SERVICE LETTER

No. 520

Subject: Inspection of Turbocharger Plenum Exhaust Welds
(See attached AiResearch Service Bulletin No. 14.1.9)

BULLETIN NO. 14.1.9

FIGURE 1

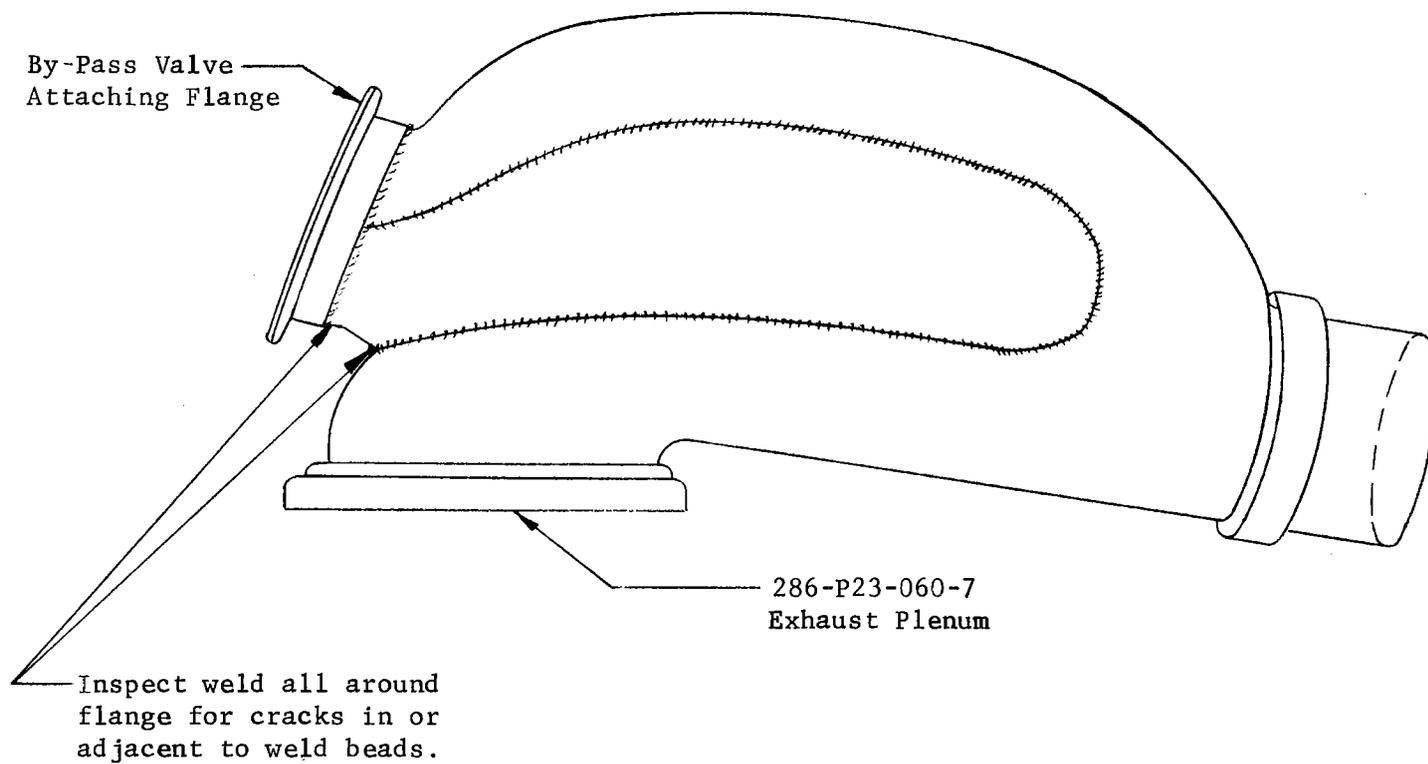
Inspect Exhaust Plenum Weld Beads, paying particular attention to the area noted in Figure I, Page 2.

Prior to further flight, visually inspect the Exhaust Plenum weld bead for cracks at the by-pass valve attaching flange. If cracking in the weld is evident, replace the Plenum immediately. If no cracking is evident during inspection, continue the Plenum in service. If aircraft time is 100 hours or more, no further special inspection is necessary. If aircraft time is less than 100 hours inspect every 25 hours until 100 hours is reached.
